SITE DEVELOPMENT PLAN

BLACK FOREST OFFICE

LANDSCAPE PLAN

PROJECT NUMBER: PPR2023
DATE PREPARED: 12-09-2020
PLANS PREPARED FOR:
BLACK FOREST, LLC
12740 BLACK FOREST RD.
COLORADO SPRINGS, CO 80908

1 LANDSCAPE PLAN
1" = 30'-0"

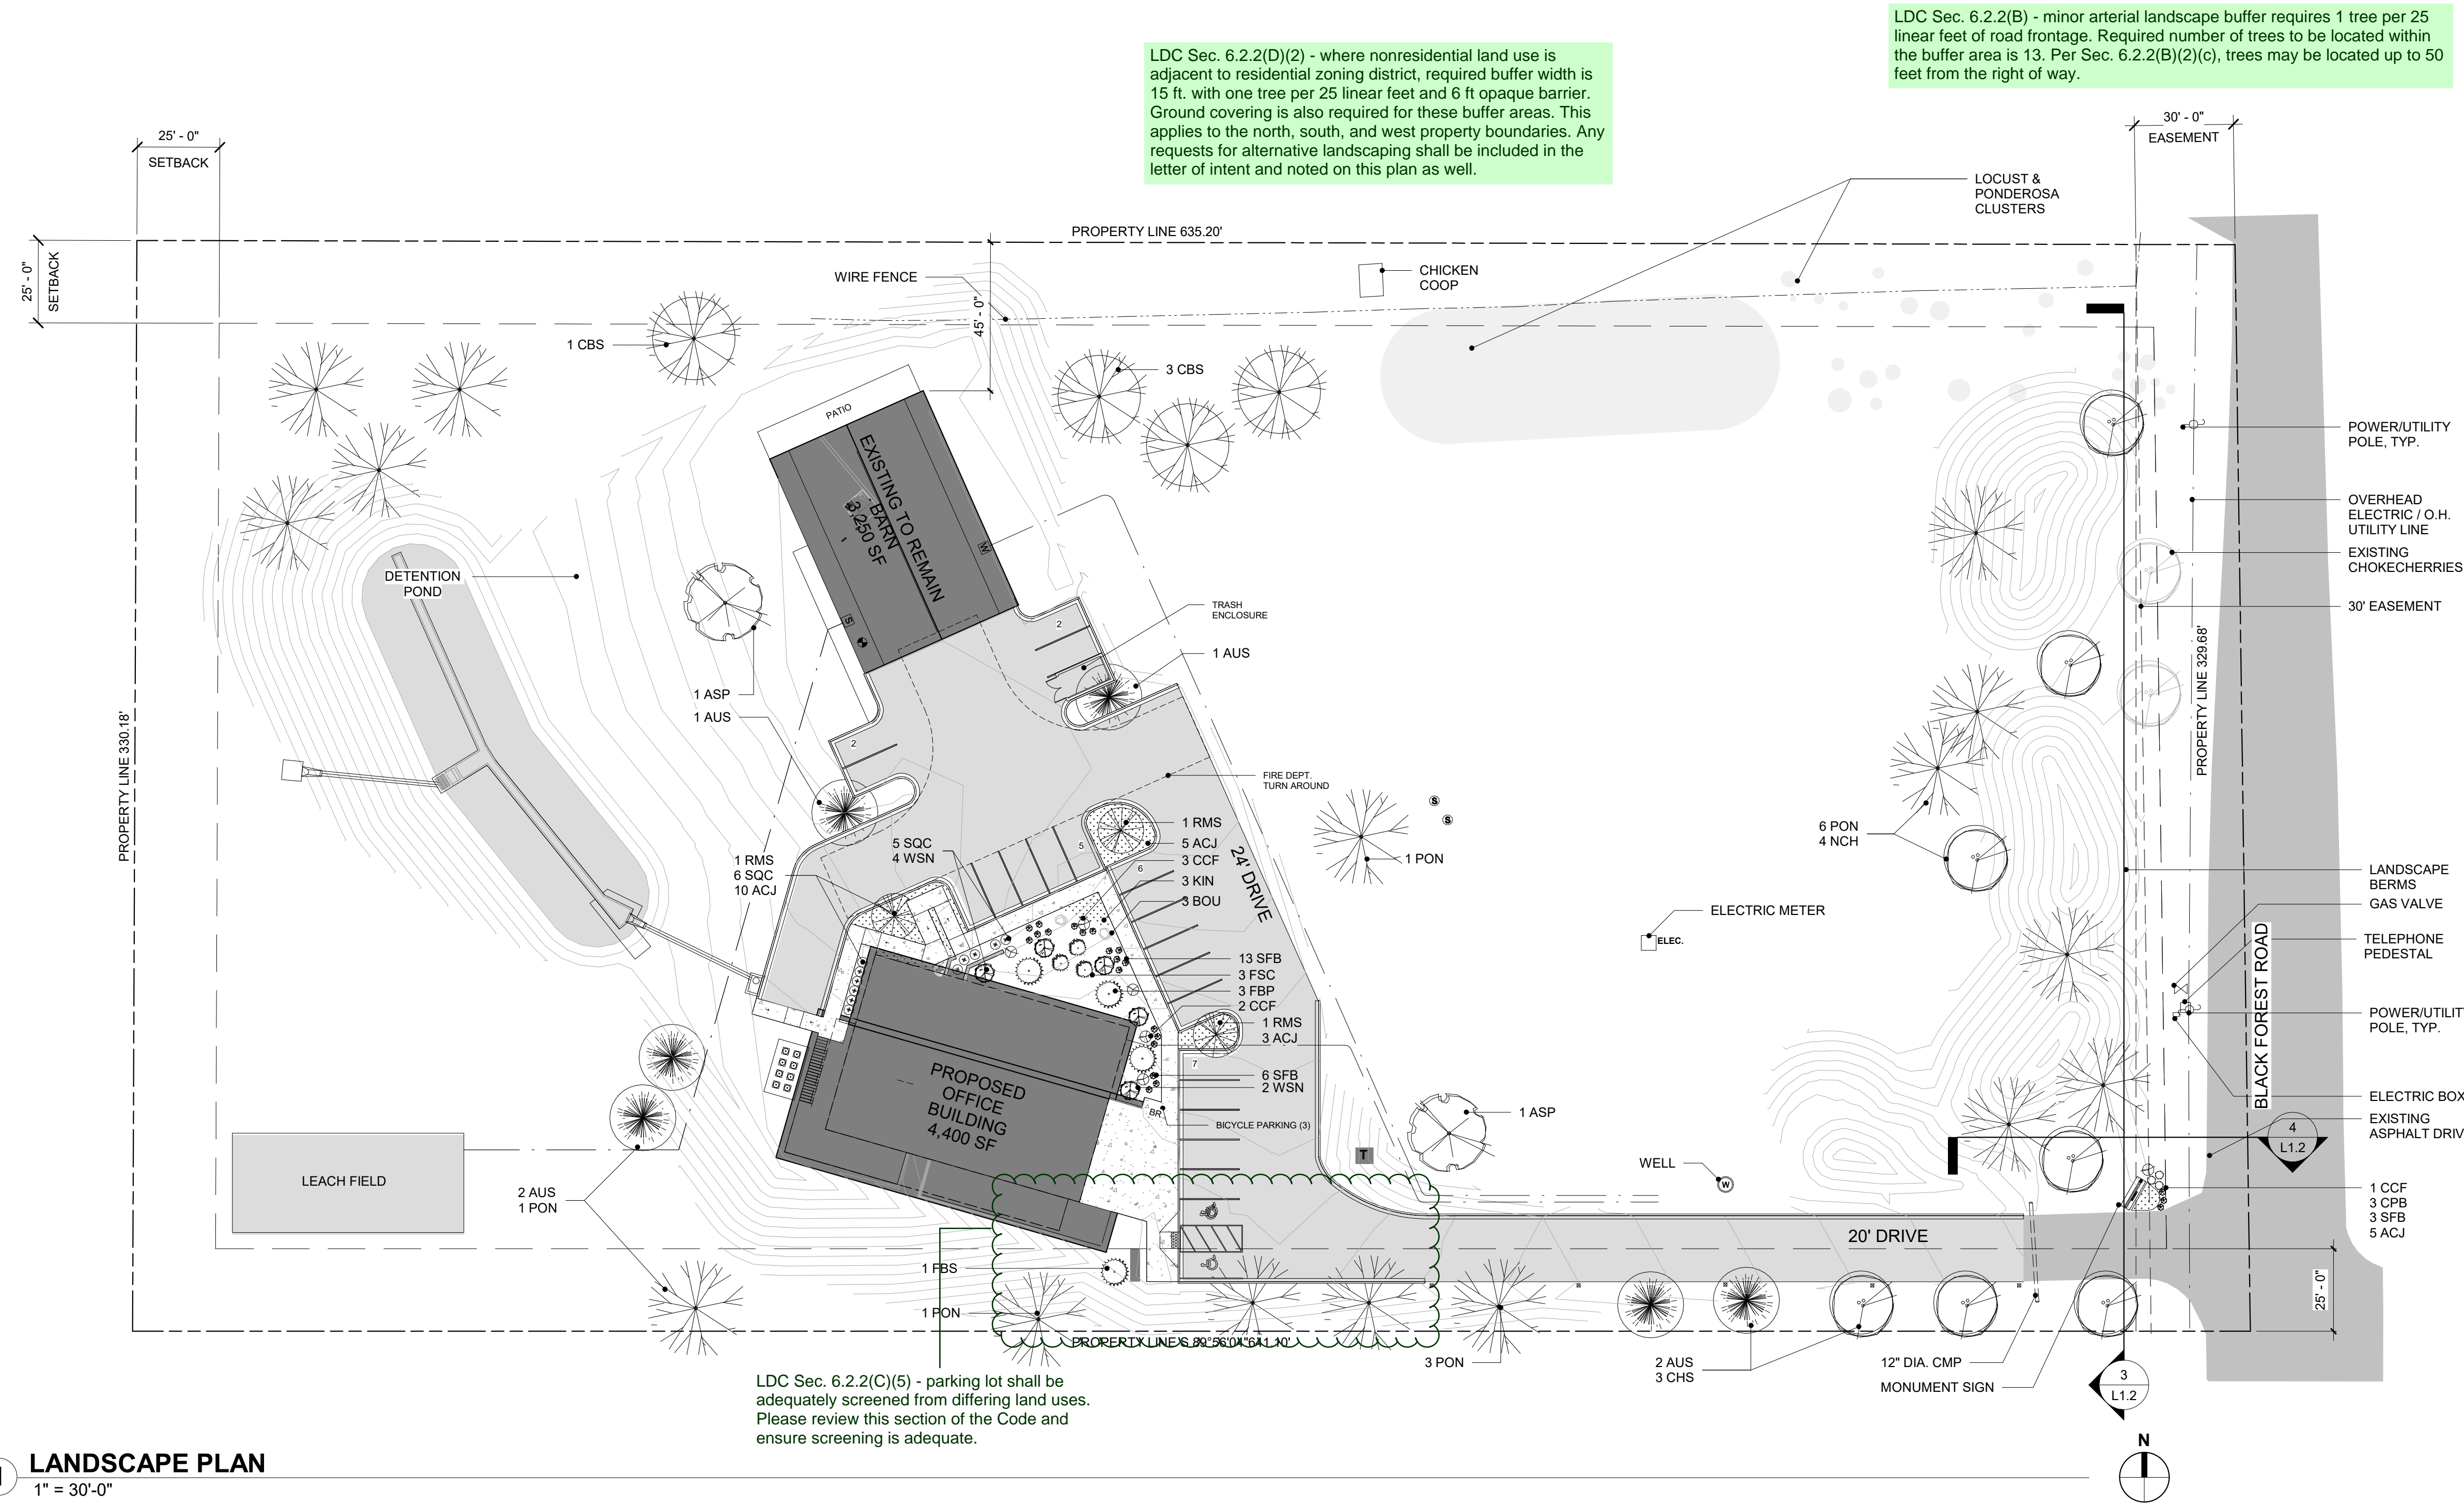
LDC Sec. 6.2.2(D)(2) - where nonresidential land use is adjacent to residential zoning district, required buffer width is 15 ft. with one tree per 25 linear feet and 6 ft opaque barrier. Ground covering is also required for these buffer areas. This applies to the north, south, and west property boundaries. Any requests for alternative landscaping shall be included in the letter of intent and noted on this plan as well.

LDC Sec. 6.2.2(B) - minor arterial landscape buffer requires 1 tree per 25 linear feet of road frontage. Required number of trees to be located within the buffer area is 13. Per Sec. 6.2.2(B)(2)(c), trees may be located up to 50 feet from the right of way.

LDC Sec. 6.2.2(C)(5) - parking lot shall be adequately screened from differing land uses. Please review this section of the Code and ensure screening is adequate.
